RFP 6 REVISED: 10/17/08ab  
ADDENDUM 4 REVISED: 8/20/07  
REVISED: 2/19/07  
REVISED: 1/24/07

6TH FLOOR PLUMBING PLAN  
ST. TAMMANY PARISH ADMIN. COMPLEX  
520 OLD SPANISH TRAIL  
SLIDELL, LOUISIANA

RENOVATE OFFICE BUILDING  
**DAMMON ENGINEERING, INC.**  
1095 FLORIDA AVENUE 985-649-5832 SLIDELL, LA. 70458  
DAMMONENGINEERING.COM

P-6

SIXTH FLOOR PLUMBING PLAN  
SCALE: 1/8" = 1'-0"

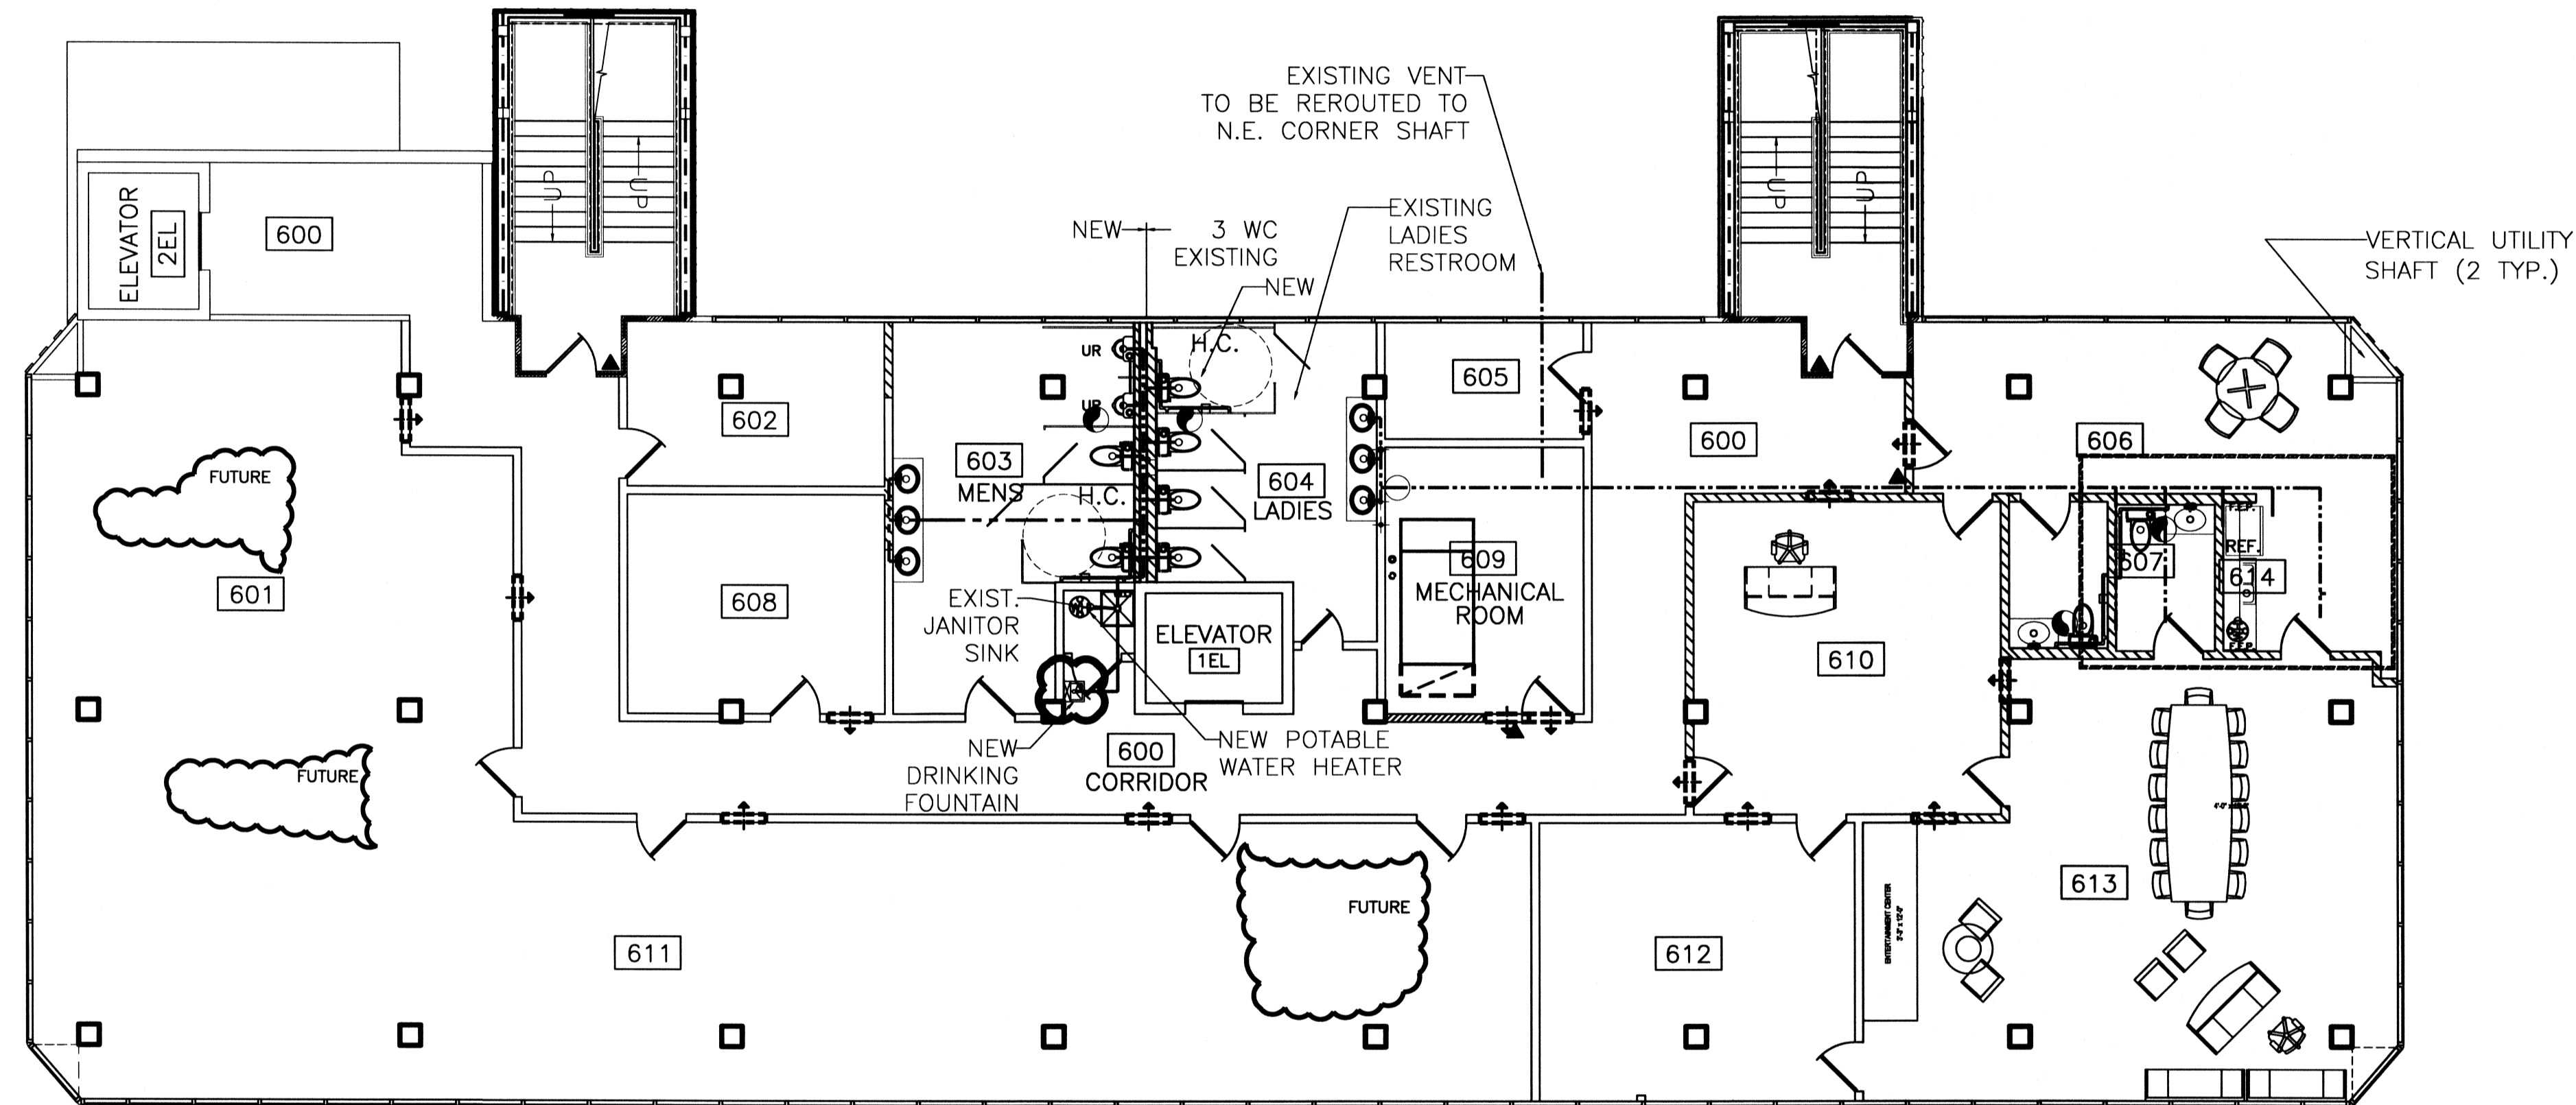
- ☐ - INDICATES ITEMS CHANGED- 10/17/08
- ☁ = ADDENDUM 4 CHANGE
